Planning and Environment Committee Meeting No. 10/14

3 21 WINBOURNE STREET, WEST RYDE. LOT 4 DP 39266. Local Development Application for Alterations and additions and change of use of existing dwelling to a childcare centre for 39 children. LDA2013/0420.

1. Report Summary

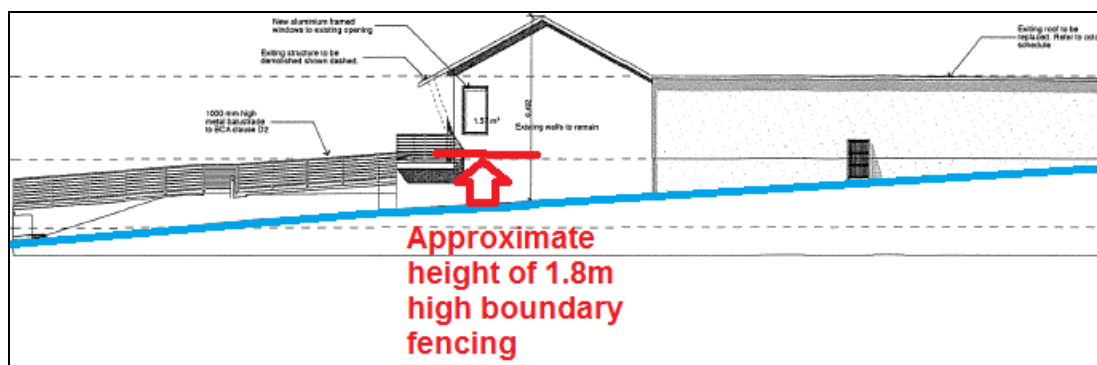
Details have not been provided outlining the daily routine of staff and each children’s age group.

The intent of this development control is to assess the noise impact of proposed child care centres within close proximity to residential properties.

Whilst an acoustic report has been submitted recommending that a 2.4m high acoustically sound fence be erected around the perimeter of the outdoor play area, details pertaining to operational management of the outdoor play area has not been submitted and therefore Council can only make a general assessment in terms of possible amenity impacts on adjoining properties.

Playroom 2 window peers well above 1.8m high boundary fence

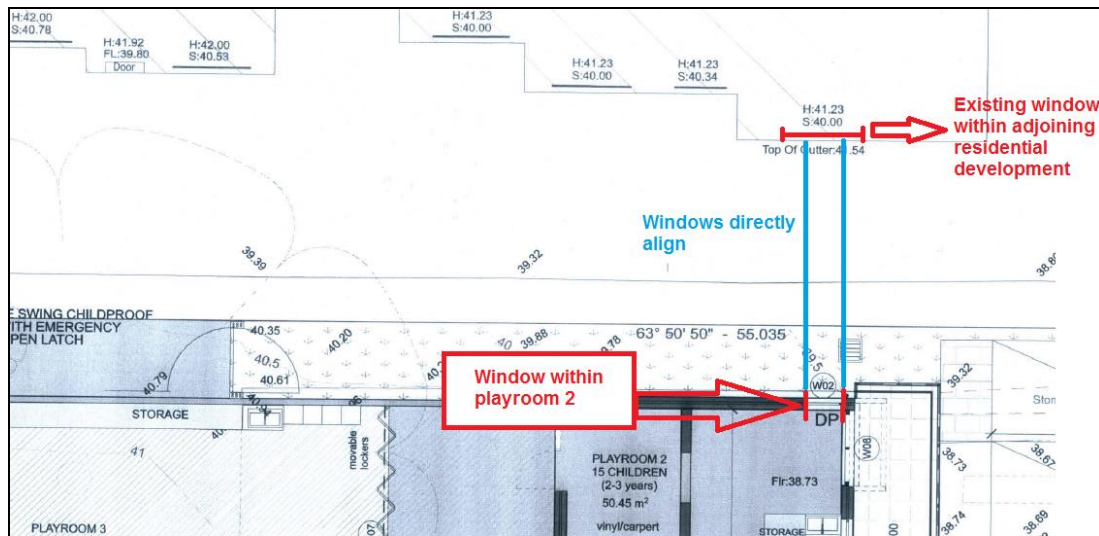
A 0.8m x 1.7m window is located along the northern side of playroom 2 which will contain 15 children between 2-3 years. The location of this window is shown in the elevation extract:

Window aligns with a window within No. 1/23 Winbourne Street

The applicant's calculation of outdoor play space

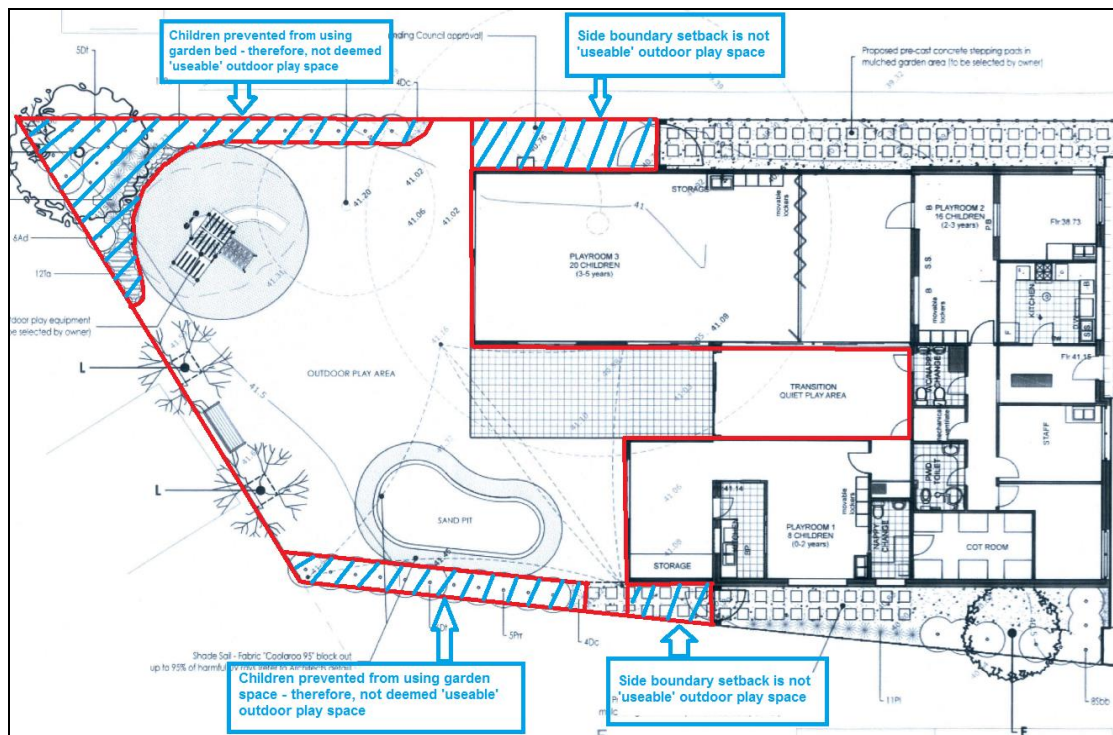
In applying these definitions, the applicant has included calculation of garden beds which are not deemed as 'useable' outdoor areas for children and portions of the side setback area which cannot be readily supervised. The following plan extracts highlight the portions of the site which cannot be counted as outdoor play space.

Council's calculation of outdoor play space

Not only does the proposal fail to achieve compliance with the DCP, compliance with the mandatory requirements of the Education & Care Services Regulation are not achieved, and when grouped with other issues of concern discussed in this section, it indicates that the proposal is an over-development of the site and that the proposed change of use of an existing dwelling is not suitable at this site. Consequently, the proposal cannot be supported.
